**Response to  
Request for Additional Information No. 371, Supplement 5**

**U. S. EPR Standard Design Certification  
AREVA NP Inc.  
Docket No. 52-020  
SRP Section: 03.07.01 - Seismic Design Parameters  
SRP Section: 03.07.02 - Seismic System Analysis**

**QUESTIONS for Structural Engineering Branch 2 (ESBWR/ABWR Projects) (SEB2)**

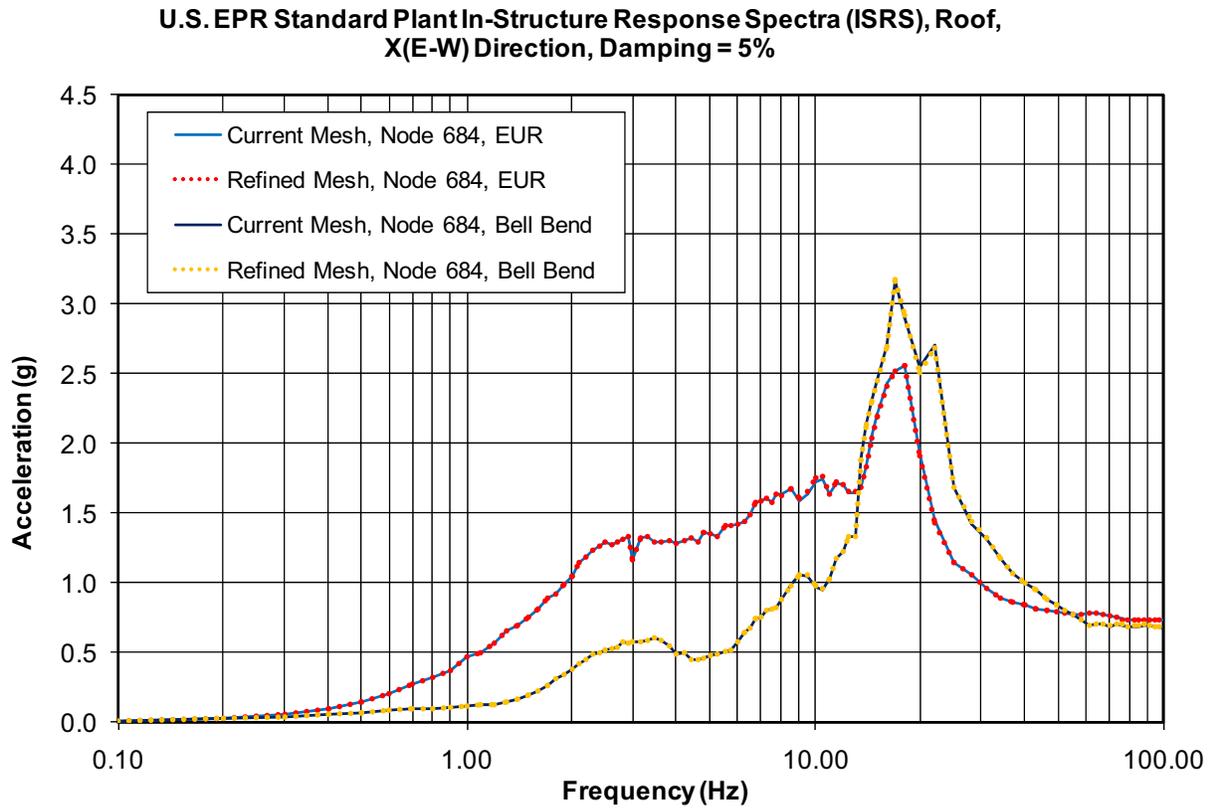
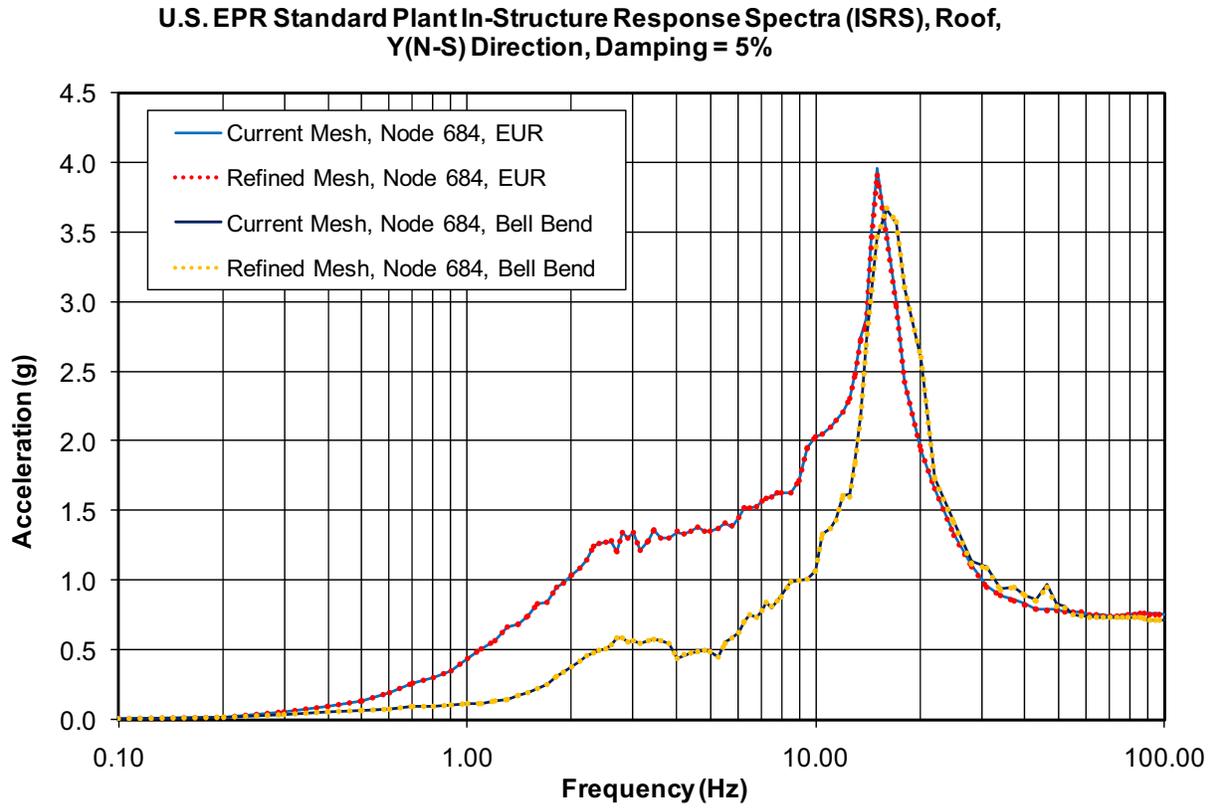
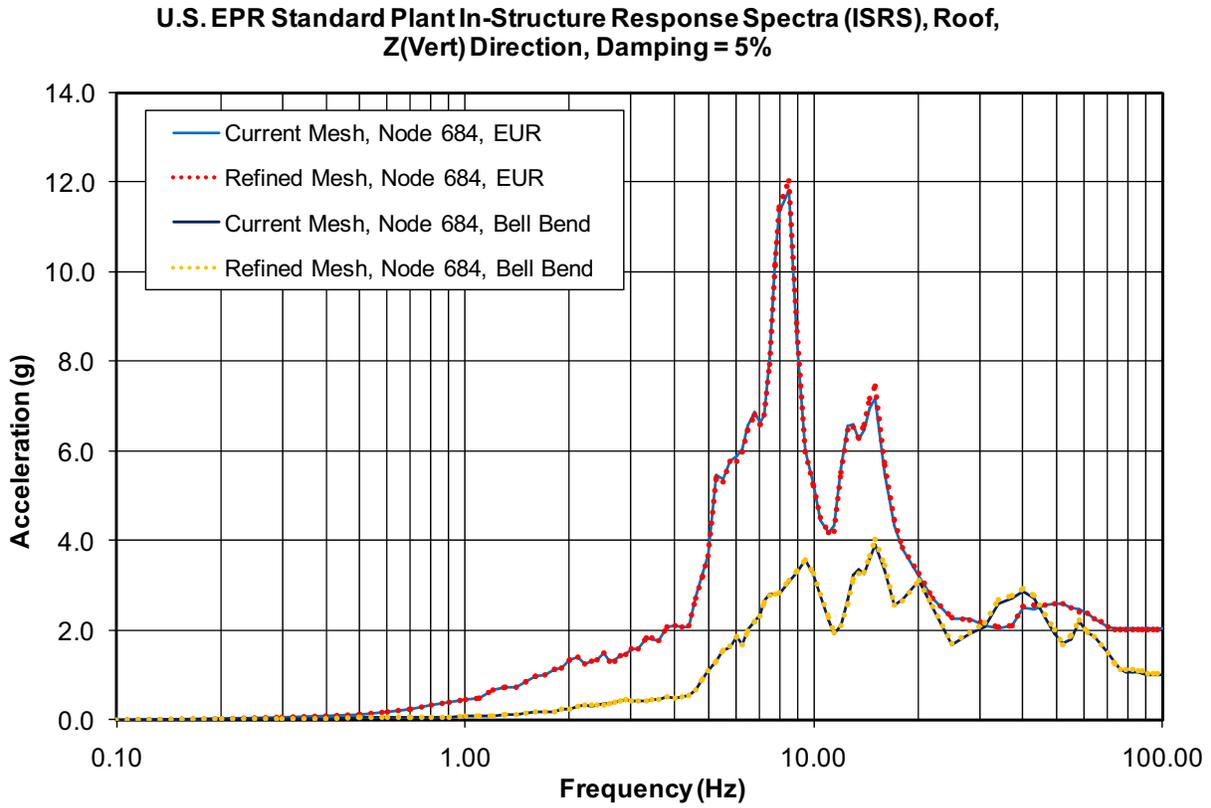
Regarding the request in **Question 03.07.02-47** to demonstrate that the seismic models for the EPGB and ESWB are sufficiently detailed so that they provide accurate results for the seismic analysis for each of these structures, the applicant has demonstrated this at only one elevation in one direction for one of the structures (the EPGB). The information provided is insufficient to conclude that the models are sufficiently detailed to provide accurate results and meet the guidance of SRP 3.7.2, Acceptance Criteria 3.C.ii. The applicant is requested to provide additional examples for the EPGB as well as examples for the ESWB at several elevations for all three directions of seismic excitation (x,y,z).

The Essential Service Water Building (ESWB) and the Emergency Power Generating Building (EPGB) finite element models were analyzed. The length, mass, and thickness of the floor spans and the number and size of the finite elements used to discretize the spans were considered to examine the quality of the mesh for the models. The EPGB has a less refined mesh compared to the ESWB, and was selected for the mesh accuracy study. Two simplified models of the EPGB were generated. The first model used the existing EPGB mesh and the second model used a refined mesh that was half the size of the existing mesh.

The EPGB in-structure response spectra (ISRS) were plotted for several key locations at different elevations and in all three directions. The responses are the result of two input motions, which were derived from the European Utility Requirements and Bell Bend motions. The responses consider approximate structure-soil-structure interaction effects between the Nuclear Island (NI) and the EPGB, and are characterized by dominant low and high frequency contents, respectively. Figure 03.07.02-71-1 through Figure 03.07.02-71-6 show a match between the current and refined mesh results in the frequency range. Node 654 is located at the center of the internal shear wall. Node 684 is located at the center of a roof slab.

The mass participation ratios for the simplified models discussed above were revised. The participating number of modes was increased from all modes below 100Hz to all modes below 200Hz.
